# SYPHON RESERVOIR IMPROVEMENT PROJECT

Final Environmental Impact Report  
State Clearinghouse #2019080009

Prepared for  
Irvine Ranch Water District

July 2021

**Figure 3.12-1**  
Regional and Local Roadways

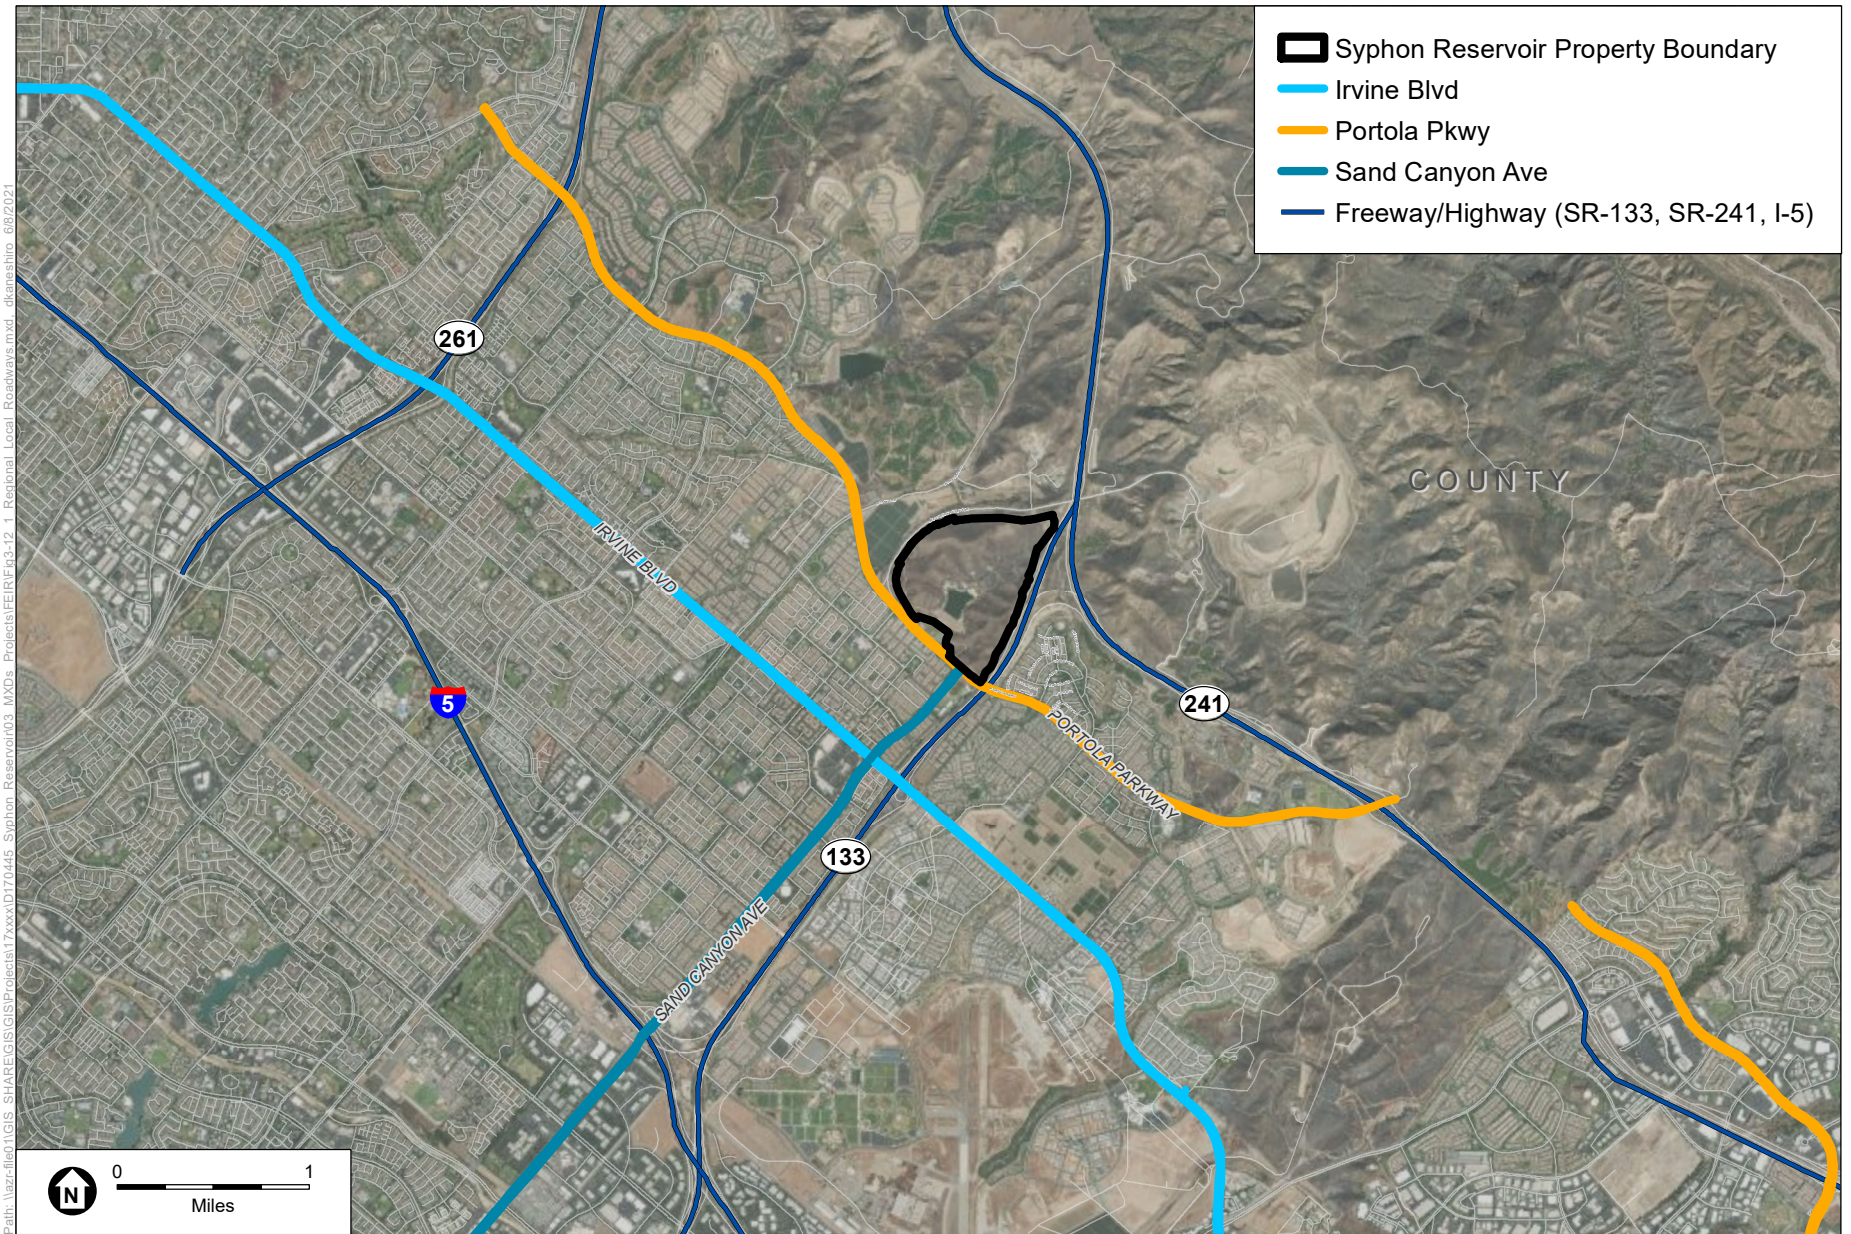
2. Figure 3.12-1 Map legend – please add freeway/highway (I-5, SR-261, SR-241) leg.
3. Consider including a discussion on general transportation safety improvements, especially for vulnerable road users such as bicyclists and pedestrians.

In response to the comment, Figure 3.12-1 has been revised to include freeways/highways and is included in Chapter 11 of this Final EIR.

The legend of **Figure 3.12-1** has been revised to include freeways/highways.
